Delegated officer report for planning application

Application no. 144118/FO/2025
Date registered valid: 30 September 2025
Proposal: Installation of digital LED totem.
Address: Outside No. 8-10 Exchange Street, Manchester, M2 7EF
Ward(s): Deansgate Ward

Recommendation: Refuse
Date of recommendation: 25/11/2025

Existing totem (left) and proposed totem (right)

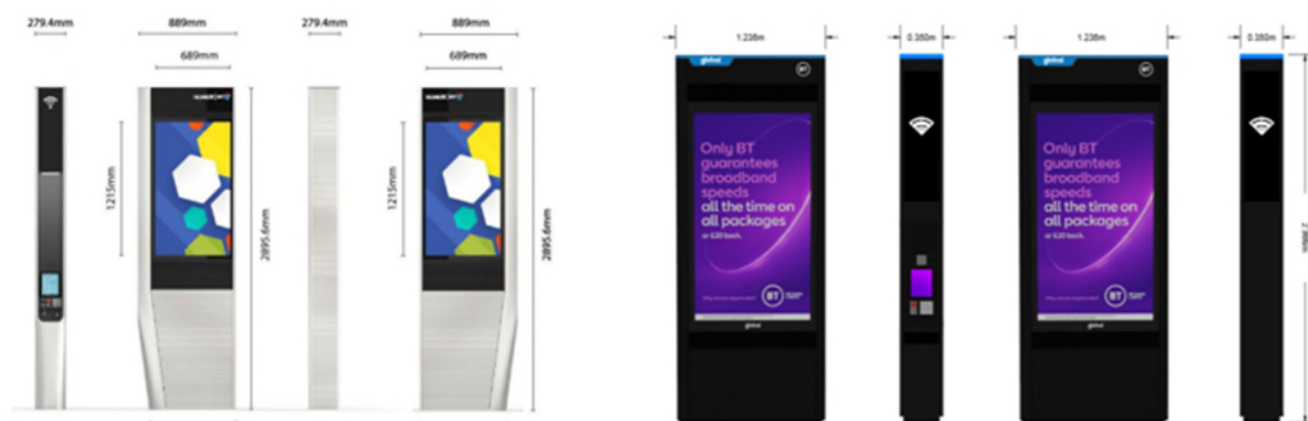
The proposed development would see the existing LED totem on site replaced with a new model that is 1236mm wide, 350mm deep and 2986mm high. A comparison of the existing unit to that of the proposed is shown below:

The proposed totem in comparison to that of the existing, is a larger, bulkier and darker structure, representing an intensification of development on the application site, by virtue of which would have a greater impact on the setting of the St Anns Square Conservation Area and neighbouring listed buildings, causing a low level of less than substantial harm to the setting of said heritage assets, as well as further impacting the local street scene, thereby undermining regeneration efforts. The previous approval on site, permission 118433/FO/2017, secured a significant reduction in street clutter on site and within the neighbouring area, the proposed development however would be the inverse of this, with the proposed totem being larger than that of the existing, thereby increasing clutter on site and eroding the strides taken in improving the locality under the aforementioned permission.
